Preliminary & Final Drainage Report

Engineering Review

EPC Planning & Community
Development Department

Sanctuary of Peace Residential Community

MVE PROJECT 61087
 MVE DRAWING EX-DM

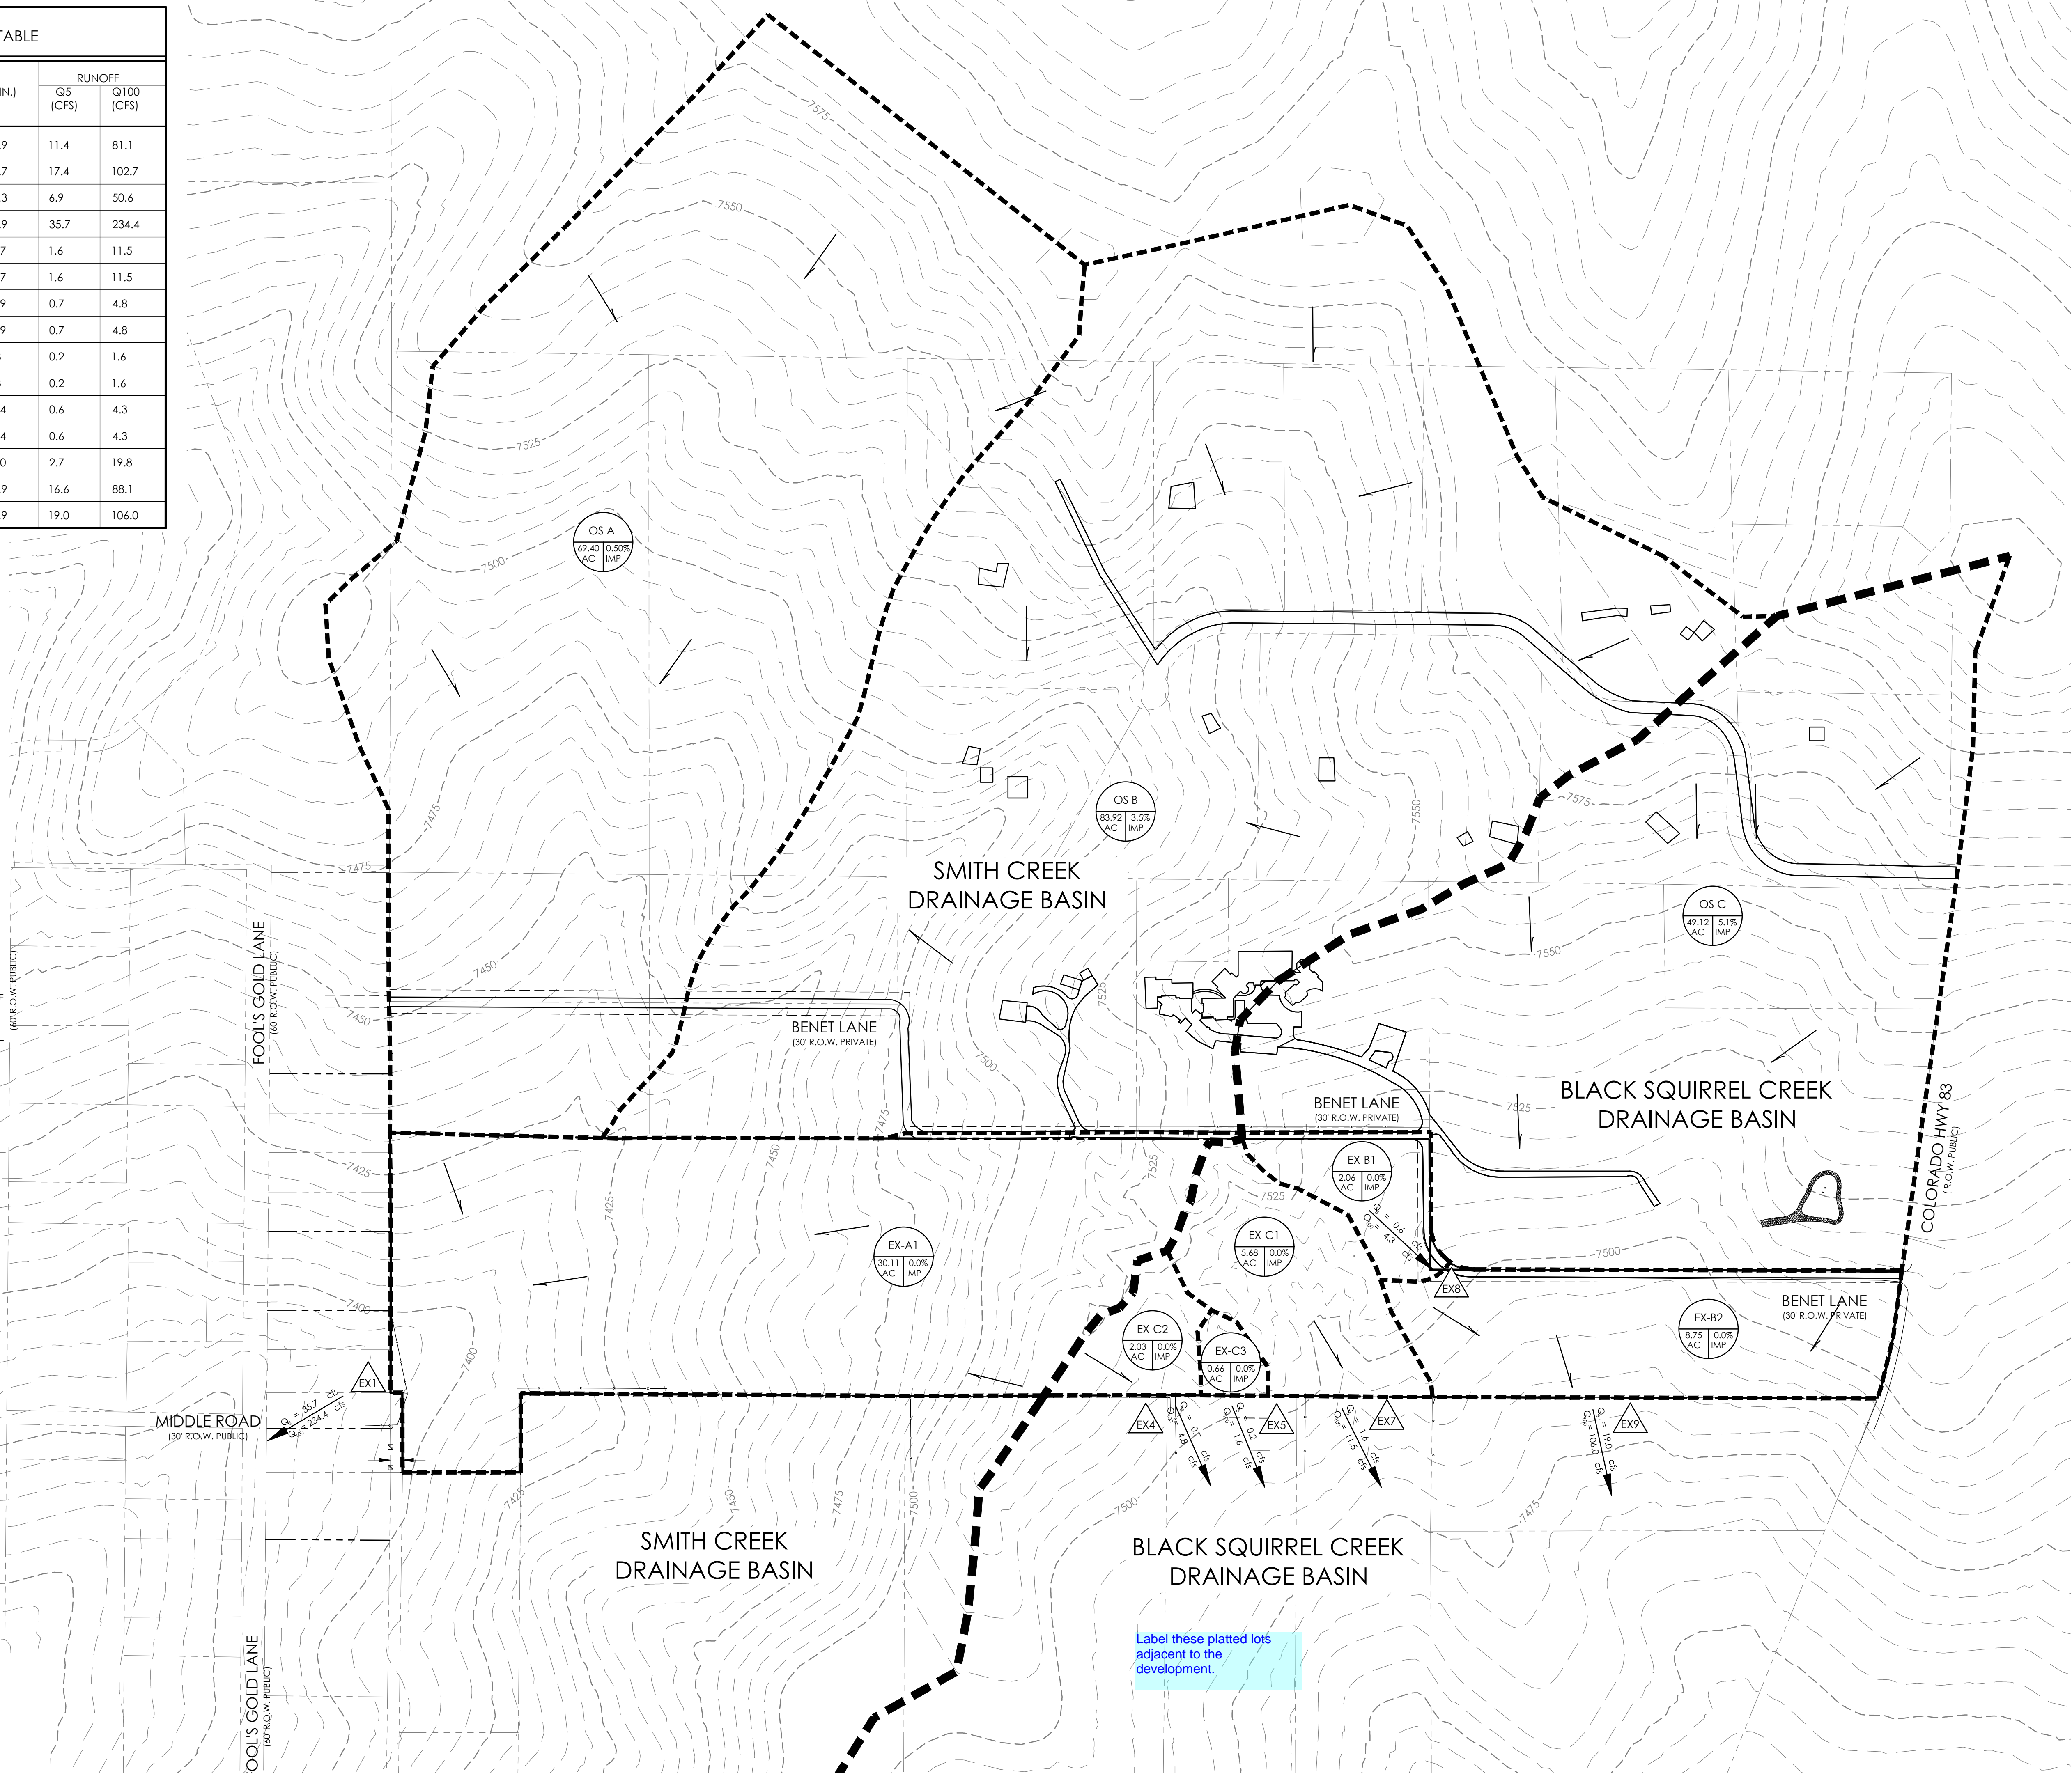
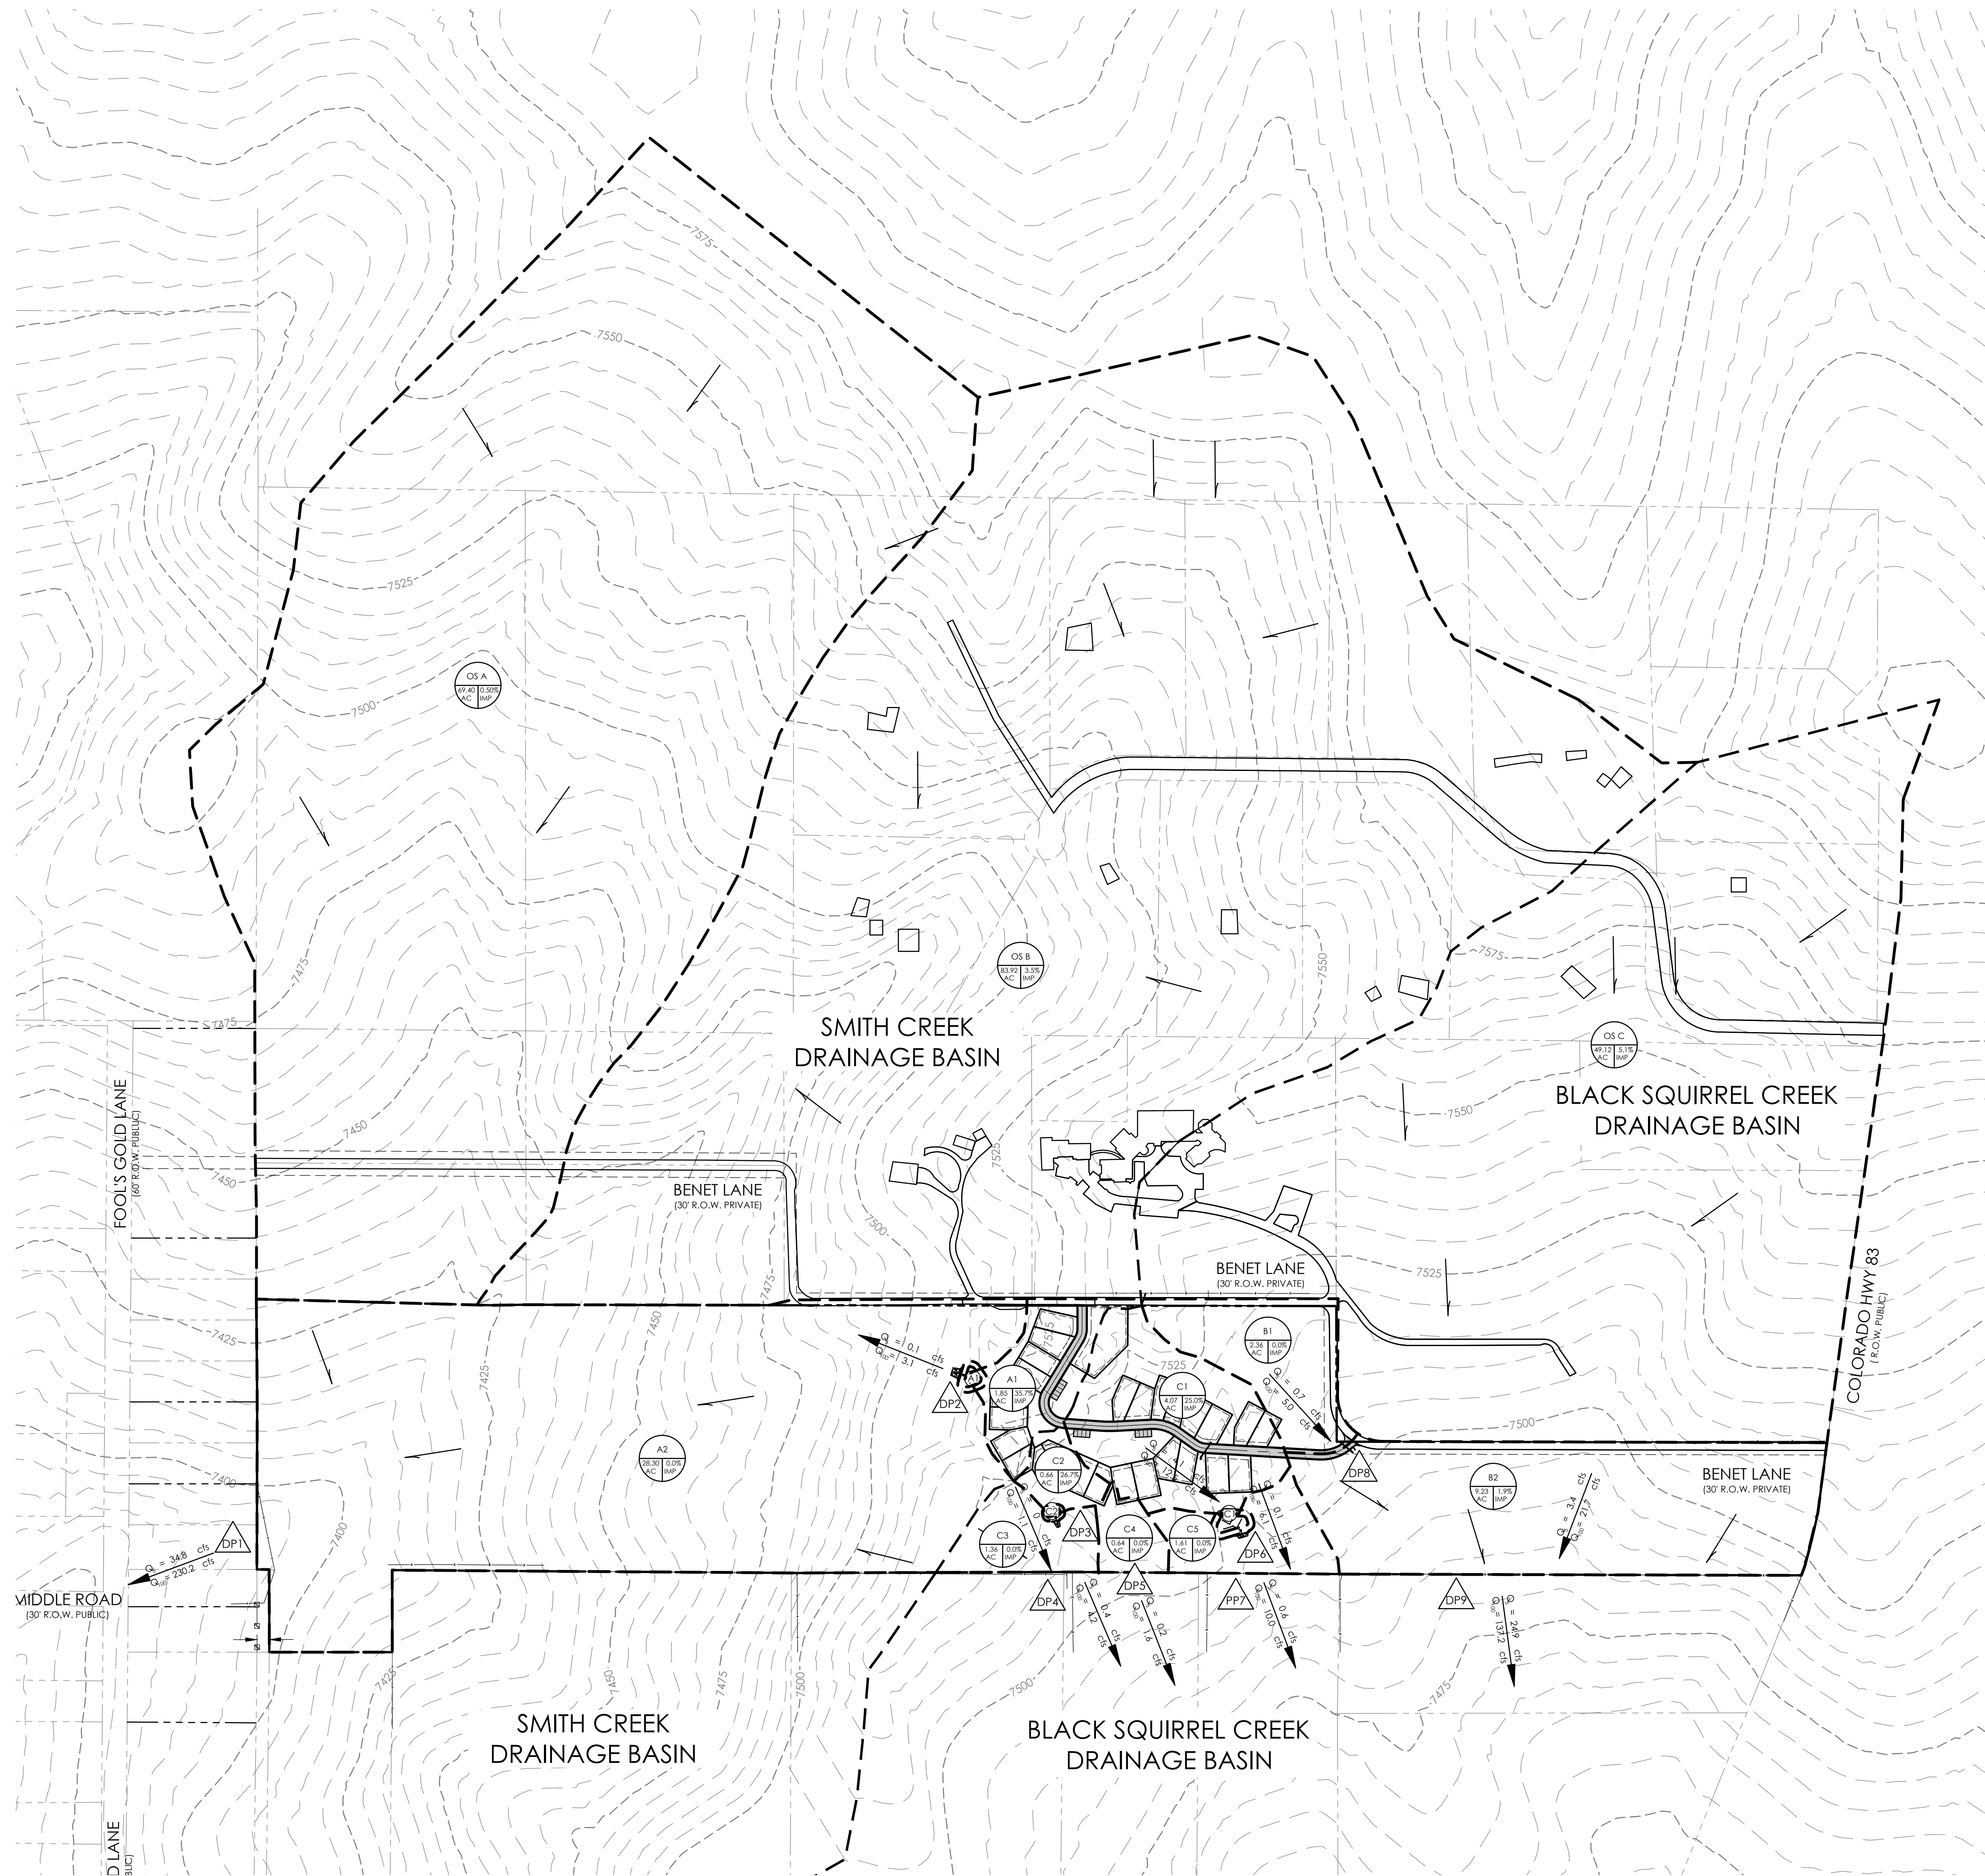
Label these platted lots adjacent to the development.

PROPOSED DRAINAGE MAP

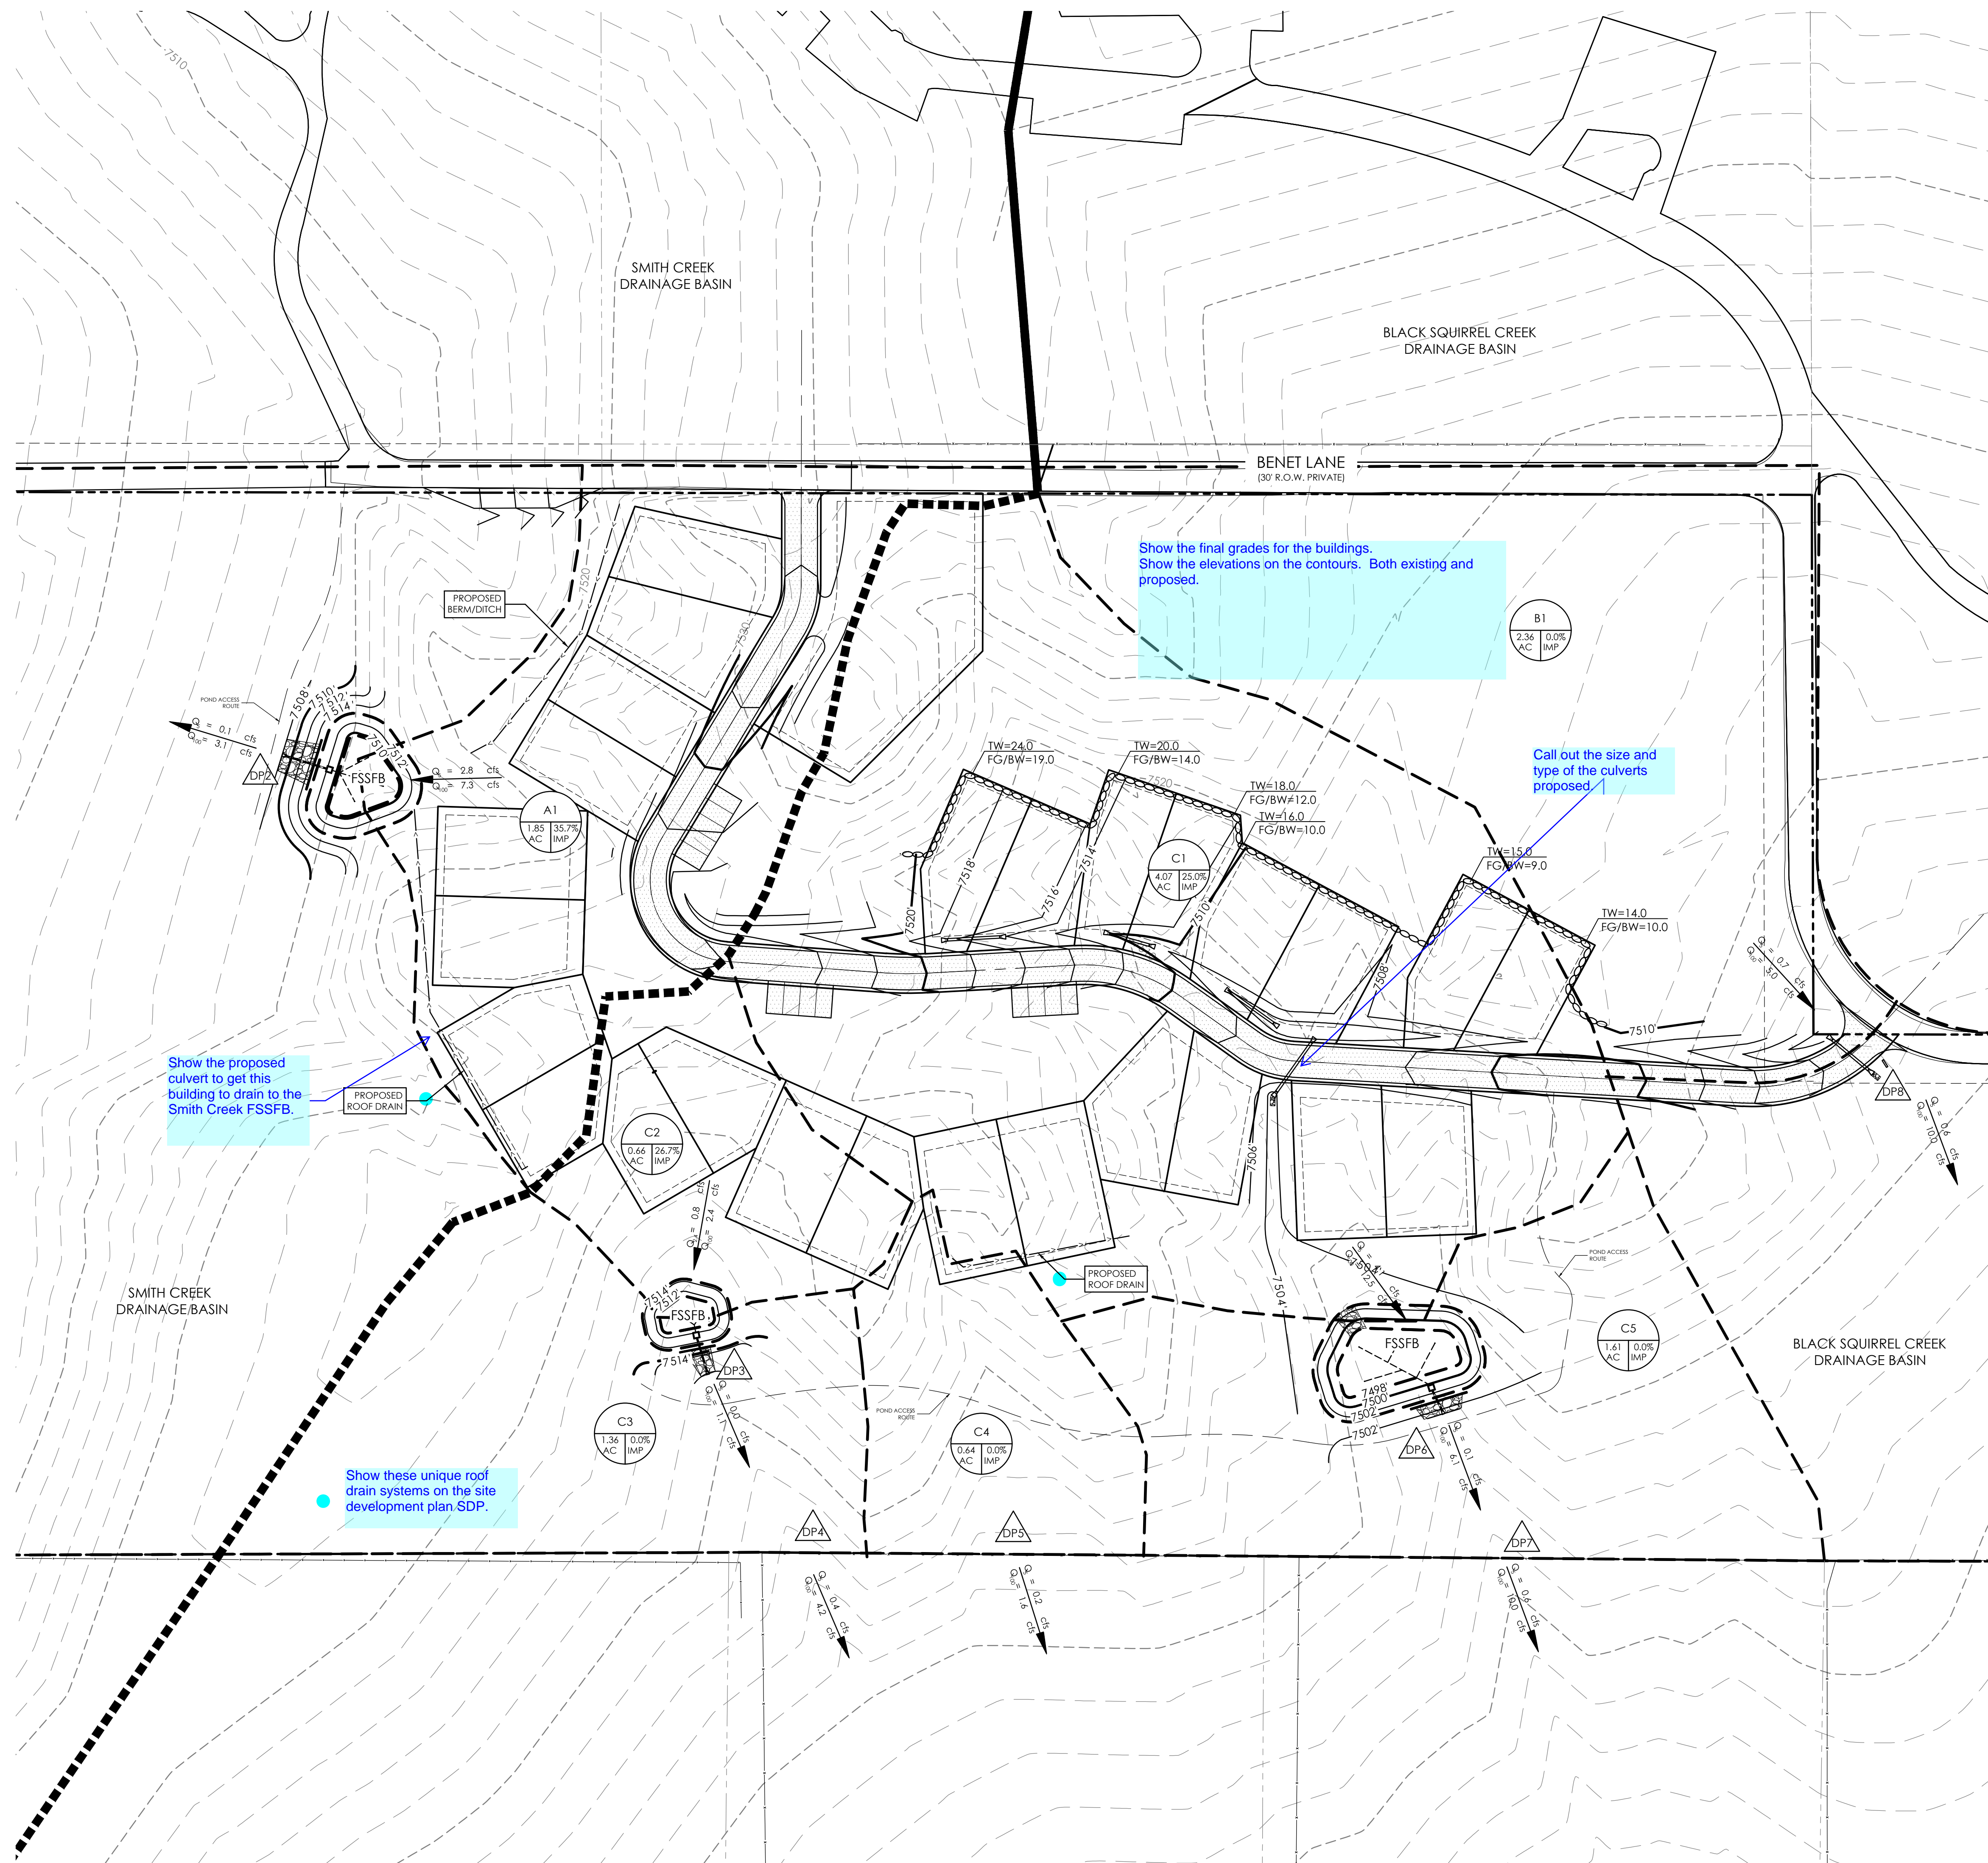
Show the final grades for the buildings.
Show the elevations on the contours. Both existing and proposed.

Show the proposed culvert to get this building to drain to the Smith Creek FSSFB.

Show these unique roof drain systems on the site development plan, SDP.
